RE: Milkwood Updated SDP

Our Reference: AFP240047-PR-MILKWOOD-R00

**MILKWOOD MANOR REVETMENT: COASTAL ENGINEERING ASSESSMENT****1. INTRODUCTION**

**Figure 3.4.1 Proposed site development plan**

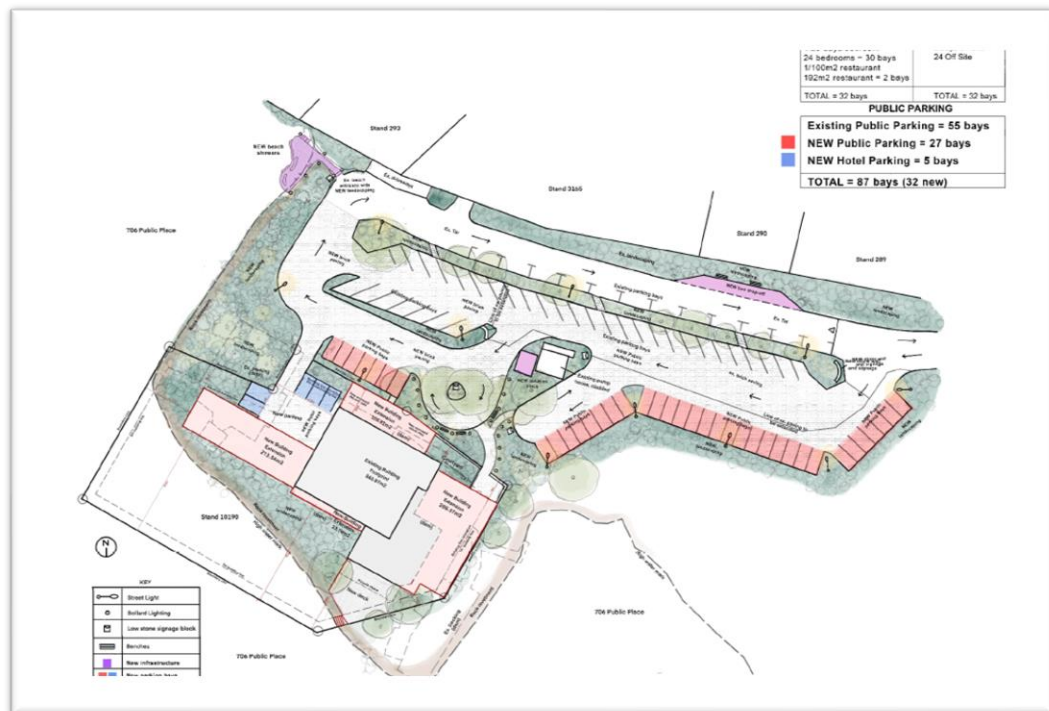
If I compare the changes proposed to the two layout options which results in two new options, notably New Preferred Layout – Option A and New Alternative Layout – Option B, then I can confirm that both options would be acceptable in terms of my original assessment.

The revetment is considered fit for purpose in terms of what has been experienced at the site to date. The new owners of the property propose making changes to the existing buildings on the site. (see Figure 3.4.1)

- Additional rock armour to be added to the structure as part the existing management plan. This will ensure that the structure is resilient into the future.
- Consideration to be given to increasing the floor levels in the buildings where possible.
- Setback lines from the sea facing section of the revetment have been considered such that wave loading and overtopping on the buildings is avoided.
- Allowance has been made for adequate drainage away from the buildings toward the estuary to prevent the build-up of flood waters should overtopping of the revetment take place.
